Beachwood Planning and Zoning Commission Meeting Agenda - Amended
Thursday, January 18, 2024, 5:00 PM
at Beachwood City Hall, Council Chambers,
25325 Fairmount Boulevard, Beachwood, Ohio 44122

RE: **P&Z 2024-1** **ThenDesign Architecture**
Beachwood Board of Education
Bryden School
Lot Consolidation Plat

RE: **P&Z 2024-2** **ThenDesign Architecture**
Beachwood Board of Education
Bryden School
Preliminary Site Development Plan

RE: **P&Z 2024-4** **ThenDesign Architecture**
Beachwood Board of Education
Hilltop School
Preliminary Site Development Plan

Plat of Consolidation

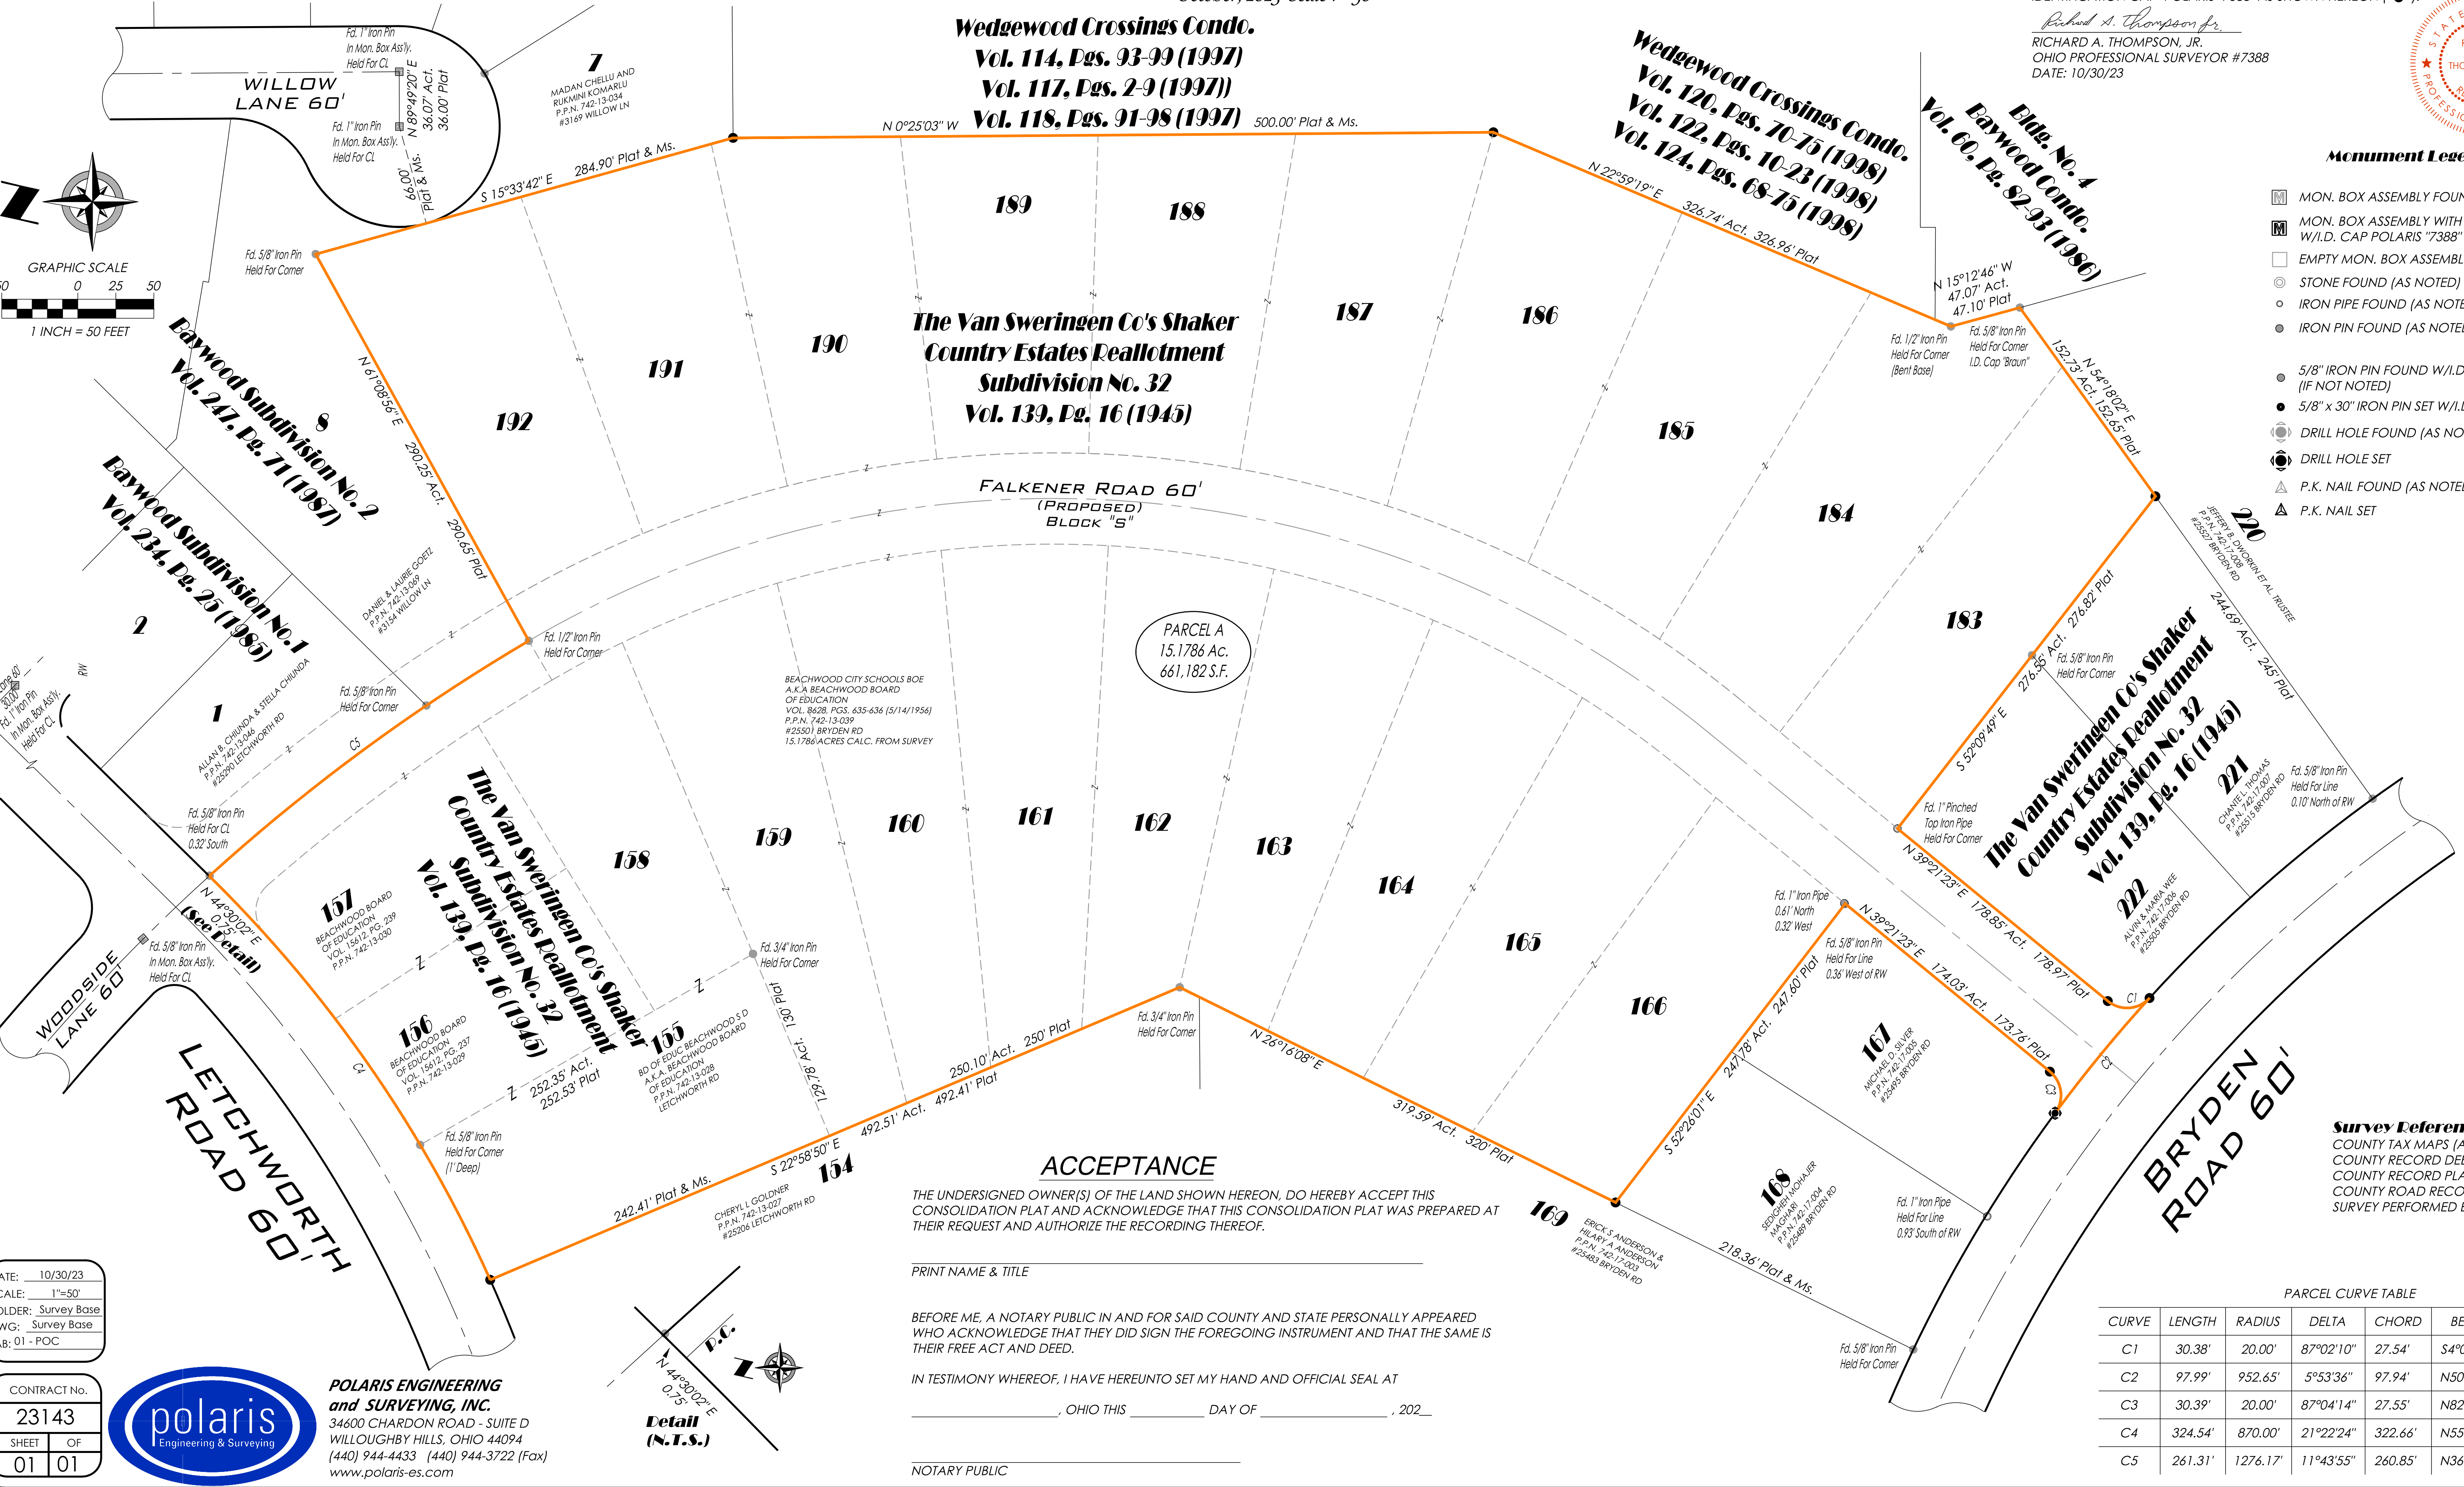
This request is for approval of a lot consolidation plat. The applicant proposes to consolidate several lots into Parcel "A" which is approximately 15.2 acres for the purpose of constructing a new elementary school. The resulting parcel would have frontage on both Bryden Road and Letchworth Road. The properties are zoned U-5 Public and Institutional District and U-1 Single Family Residential District. The City will be rezoning the U-1 zoned parcels to U-5 later this year.

This consolidation plat will combine the Bryden School Parcel (742-13-039) with 3 lots along Letchworth Road (742-13-28 thru 30), creating a 15.1786-acre parcel (Parcel A). We have reviewed the Consolidation Plat and it meets all City and the County standards and we hereby recommend approval.

It is recommended that the Commission grant approval of the lot consolidation plat subject to any comments or recommendations of the City Engineer.

*Plat of Lot Split
Chagrin Highlands*
Lands Known As Being Part Of Original Warrensville
Township Lot Number 68, Now In The City Of
Beachwood, County Of Cuyahoga In The State Of Ohio.

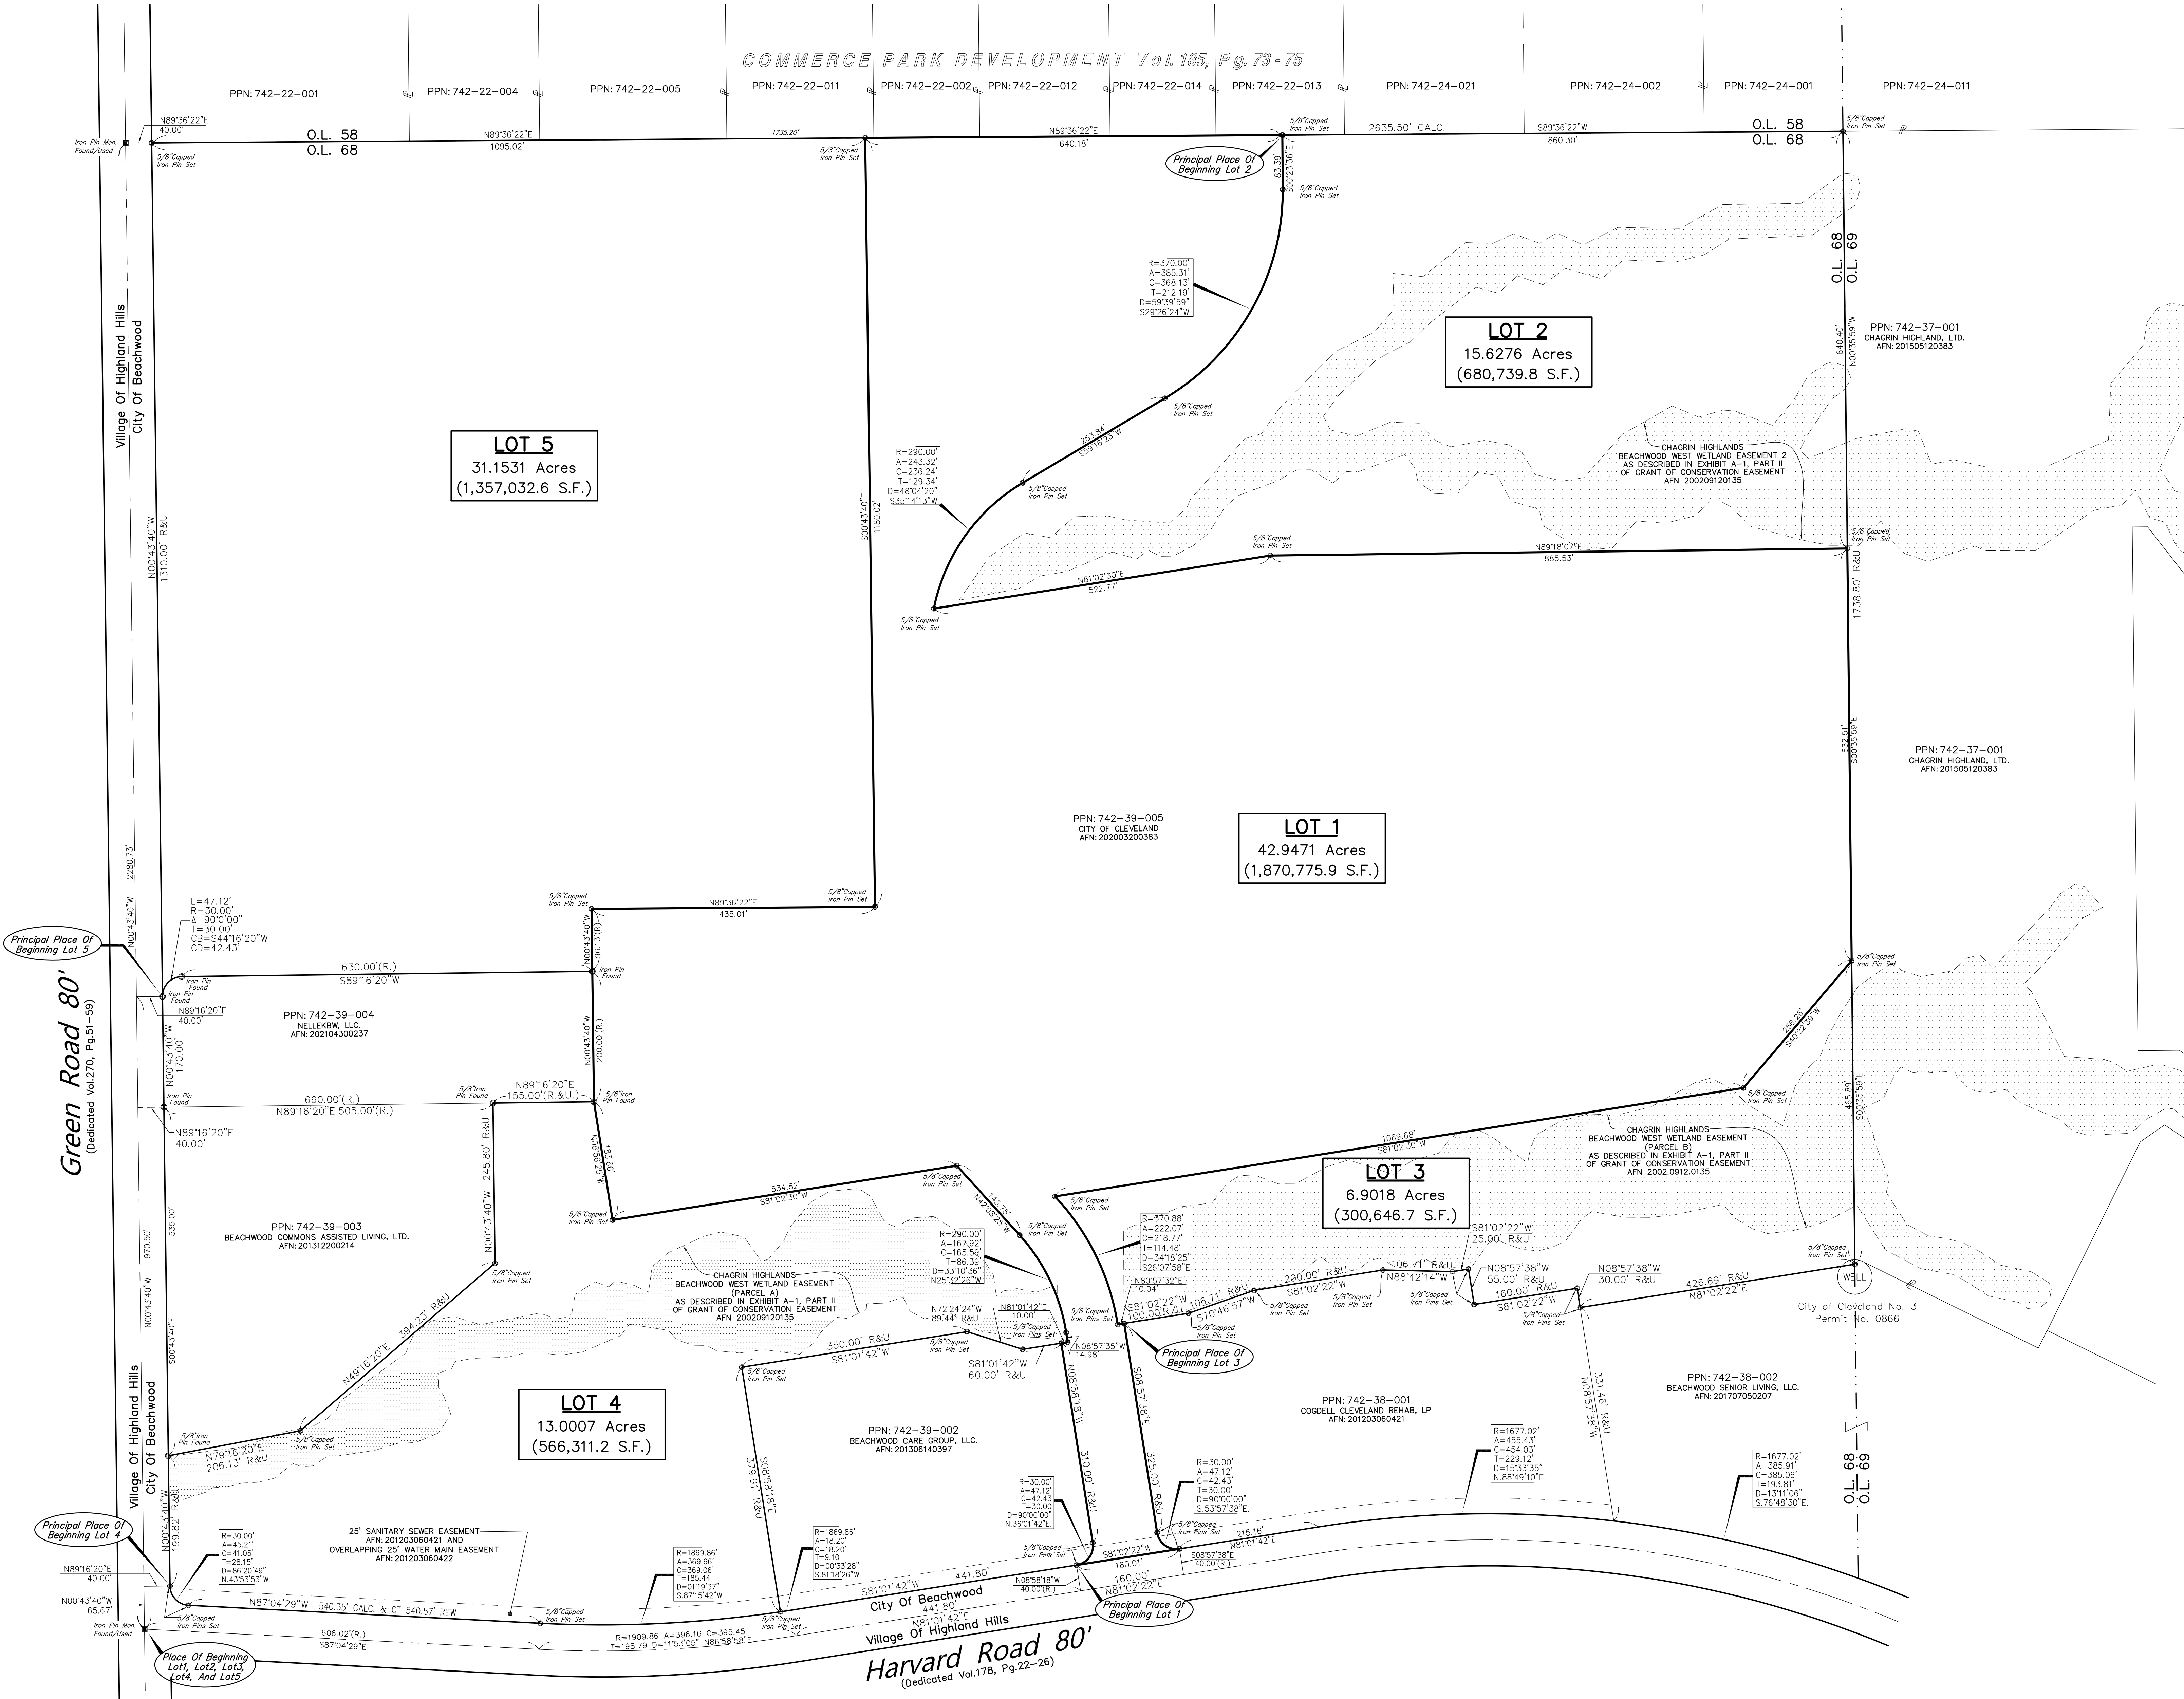
This request is for approval of a lot split plat. The applicant proposes to split existing PP No. 742-39-005 into five (5) parcels. The entire parcel is zoned U-10 Planned Mixed-Use Development District. The purpose of the lot split is to create a parcel of land (Lot 1) of approximately 43 acres for transfer to the City of Beachwood for future development and construction of the connector road from Commerce Park to Harvard Road. The City has been in negotiations with the City of Cleveland and the Jacobs Group regarding acquisition of this property.
